# Feasibility Study for Castle Peak Road Improvements

between Ka Loon Tsuen and Yau Kom Tau

**ENVIRONMENTAL IMPACT ASSESSMENT**

Report No. 97294/R38

FIGURE 8.7

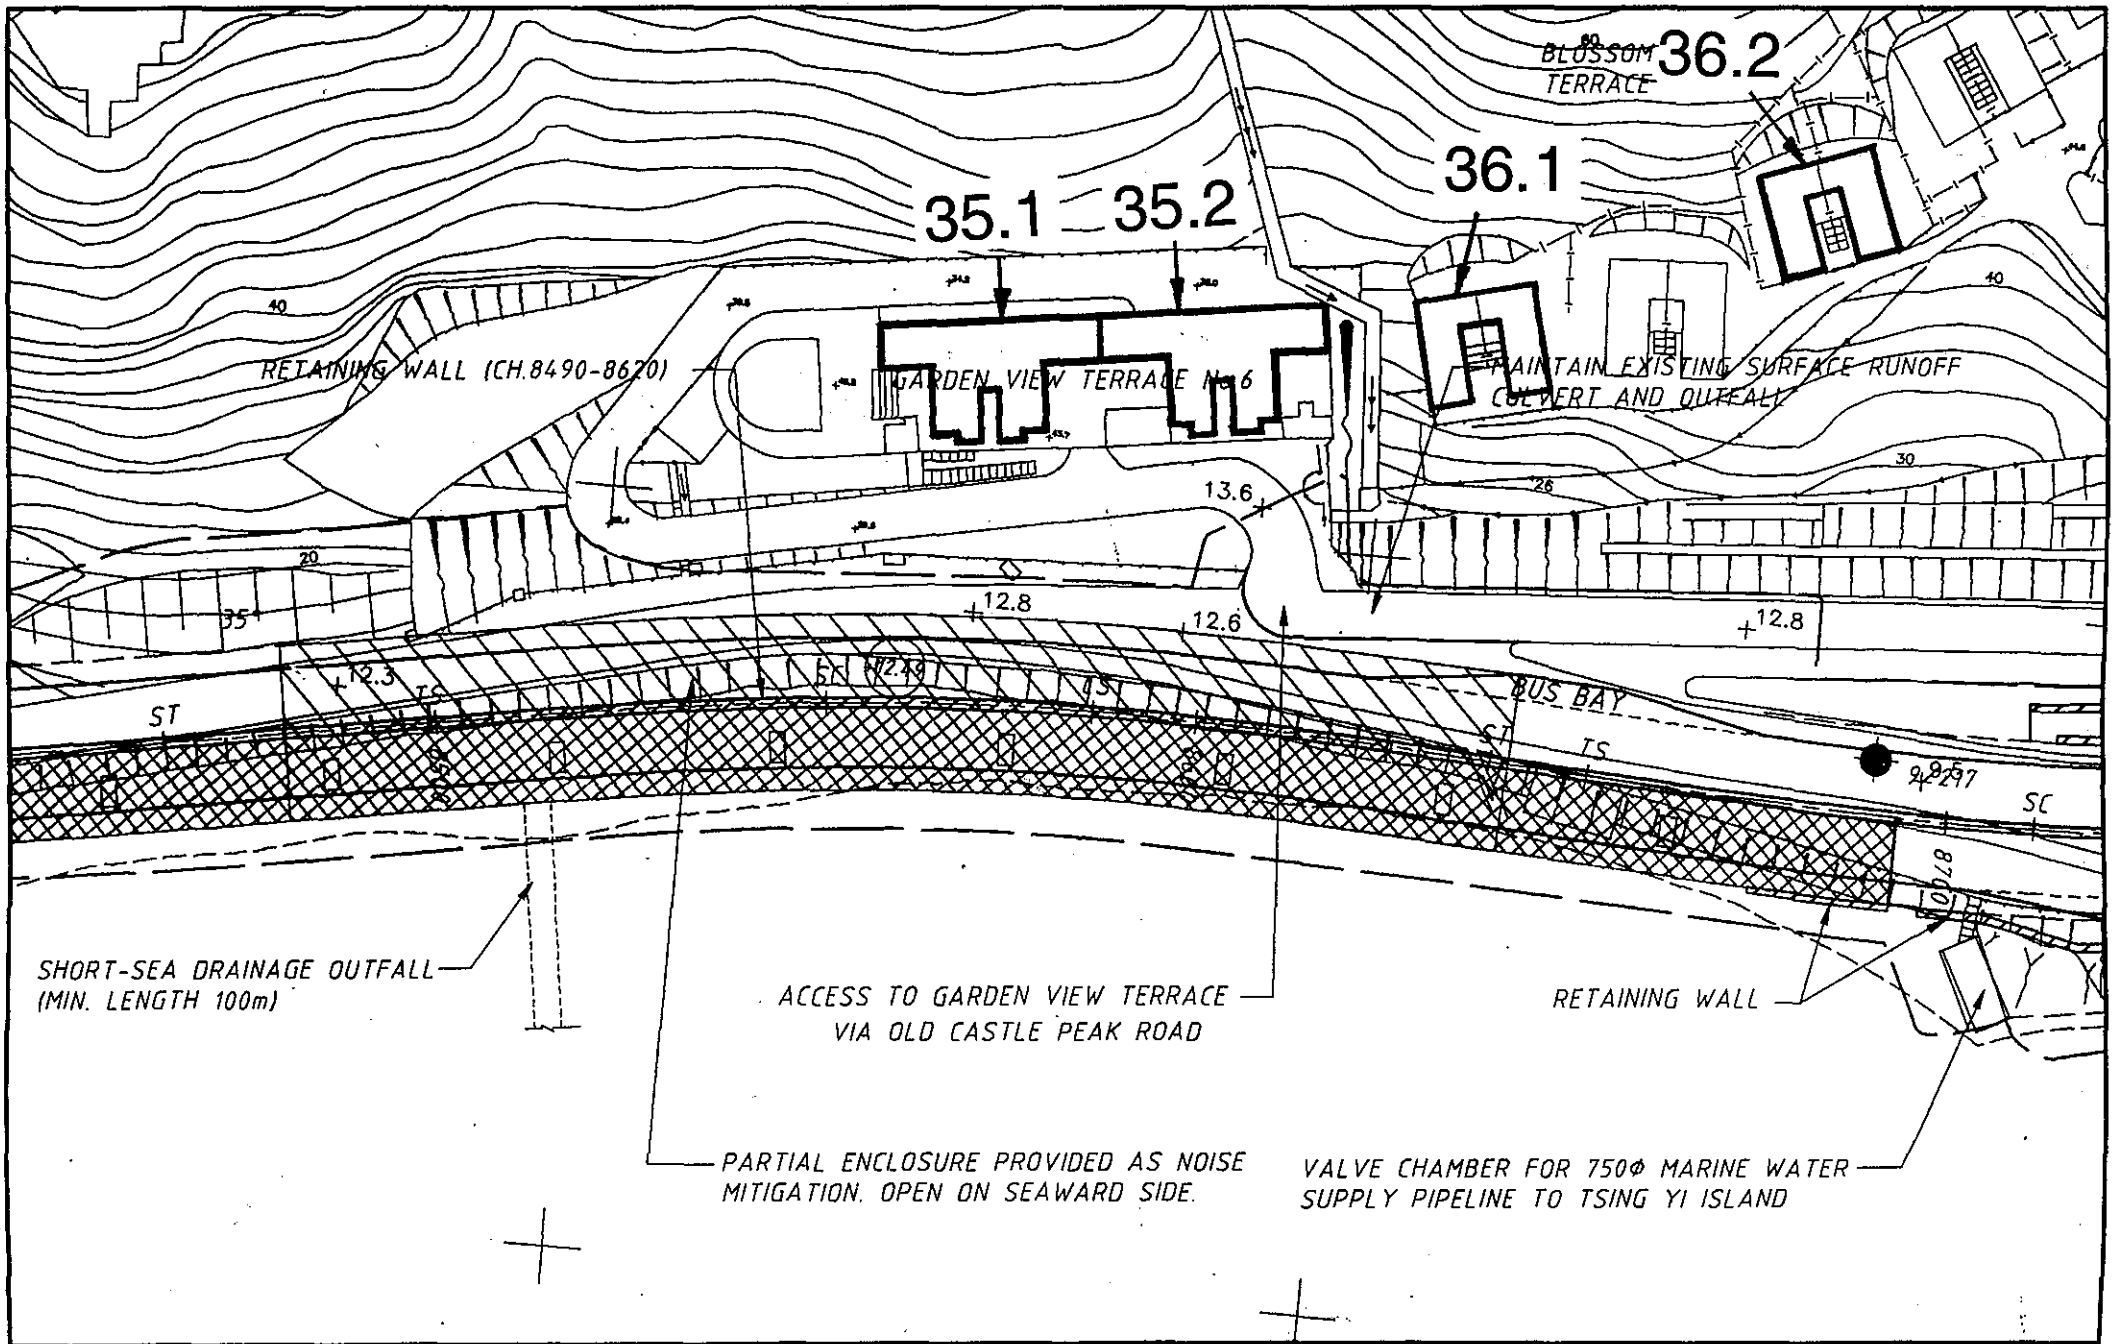
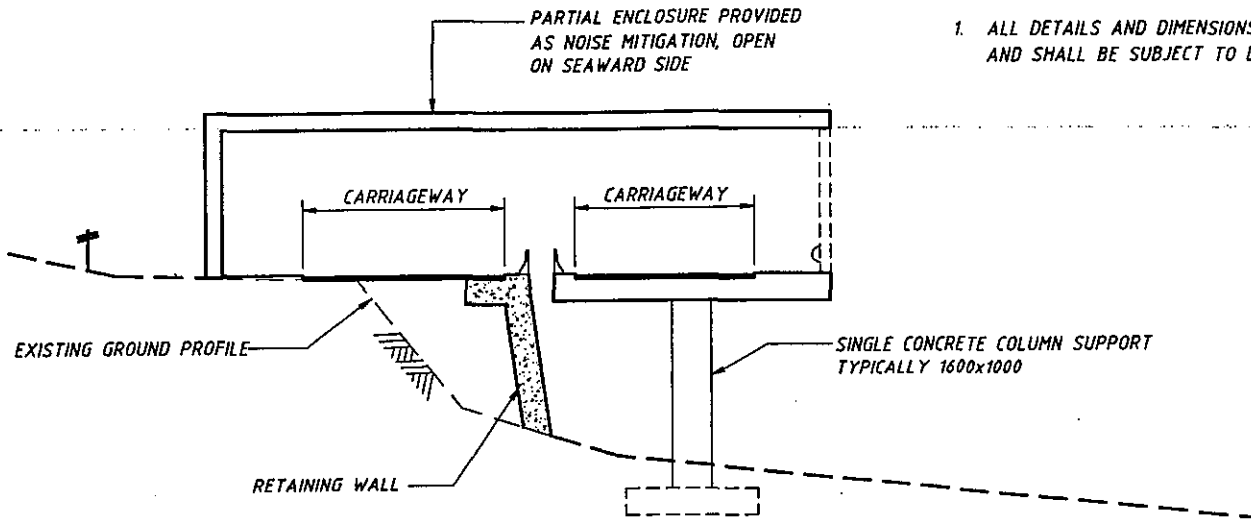
Figs 8.1 to 8.8 8. Our previous comment on 12 June 1996, item 2.13, is still outstanding.

This comment requests that locations of NSRs should be marked in Figures 8.1 to 8.8 for easy reference. Figures are being amended.

Figure 10.1 Predicted 1-Hour Average NO<sub>2</sub> Contour ( $\mu\text{g}/\text{m}^3$ ) for Yr 2011 at Height 1.5m above Local Ground (Sham Tseng Section Only, with Barrier Option)

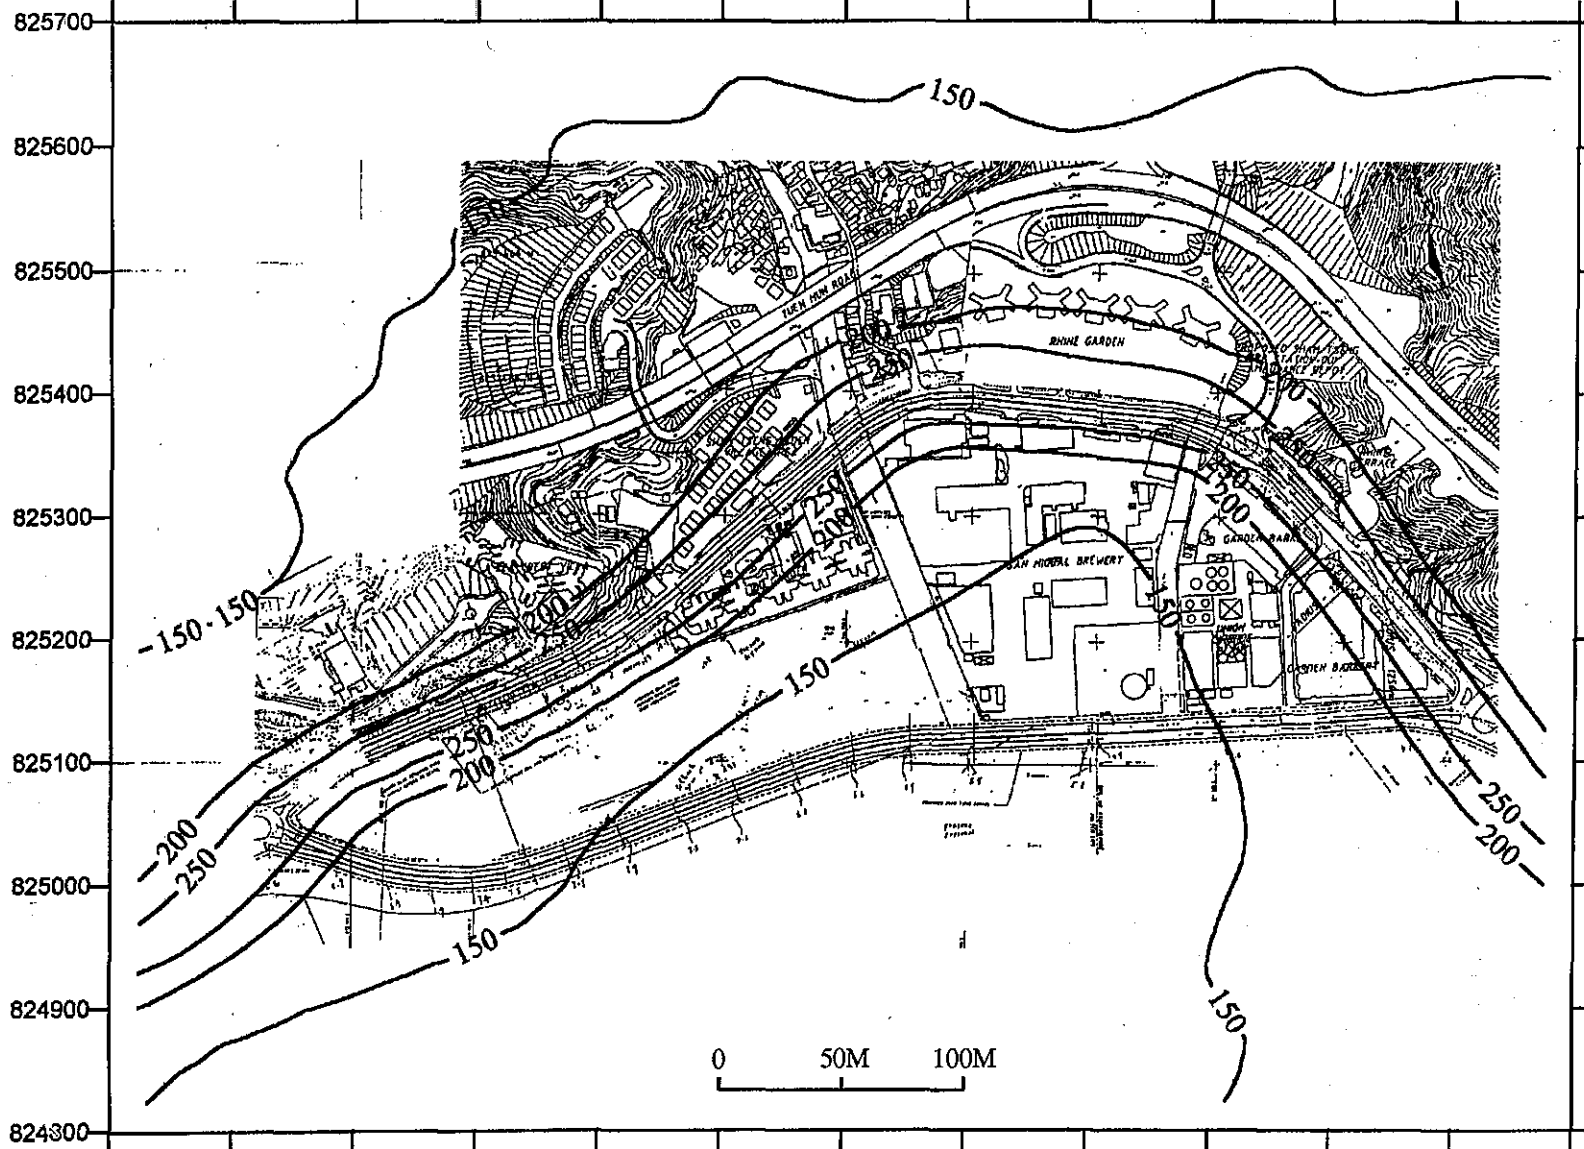
ii) S 10.1.4: It is said in the first line of the paragraph that the NO<sub>2</sub> concentration contours in Figure 10.1 does not include the estimated background concentration. It appears in Section 10.1.2 that the contour should have already included the background level. If not, there would likely be AQO exceedance at the ASRs. Please clarify.

Figures 10.1 to 10.4: Larger contour maps should be provided. This should show the scale and the contour for 300 ug/m<sup>3</sup> NO<sub>2</sub>, i.e., the AQO level for hourly NO<sub>2</sub>.

Figure 10.1 is an outdated figure and will be amended. Amended figure will be provided to EPD for review prior to its inclusion in the Final Report.

**Fig. 11.2**

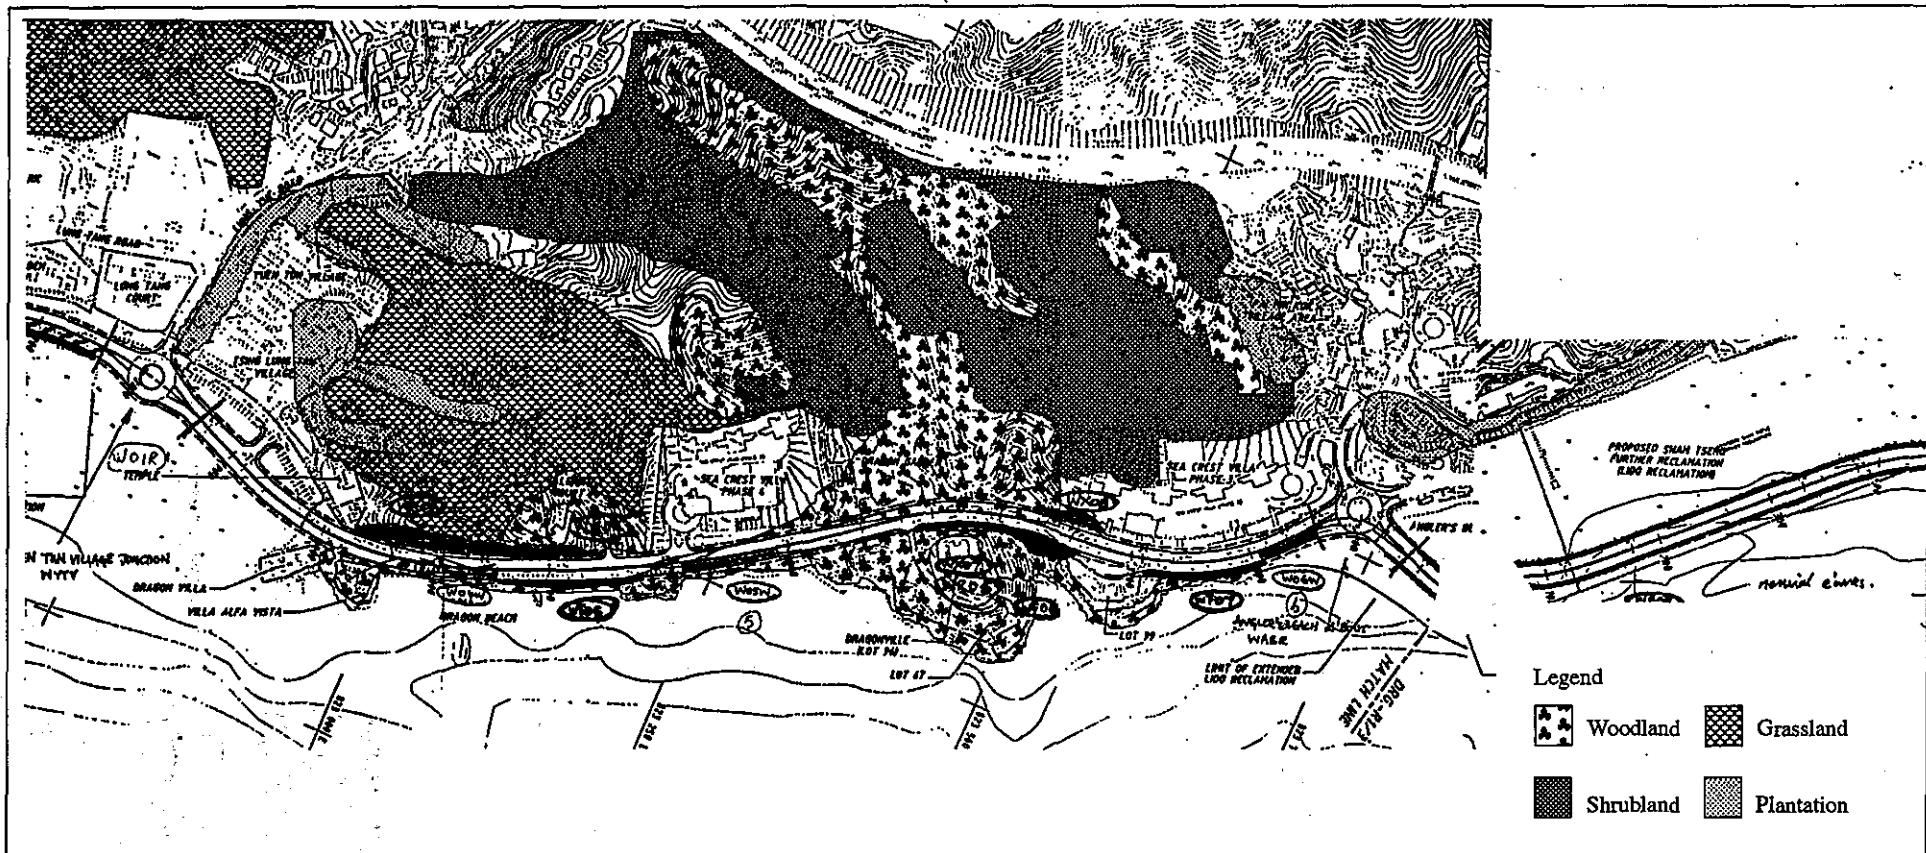
COMMENTS	RESPONSES
<p><b>From: Agriculture &amp; Fisheries Dept</b>  <b>Ref: (75) in AF DVL 14/53 III</b>  <b>Date: 7 November 1996</b></p>	
4.5.1 Line 5: The location of focused survey was not shown on Fig. 11.2.	The location is shown in Figure 11.1. Text has been changed.
Line 6: Which woodland was surveyed? Was it at Dragon Villa or Dragon View?	Dragon View woodland was surveyed. Text has been changed.
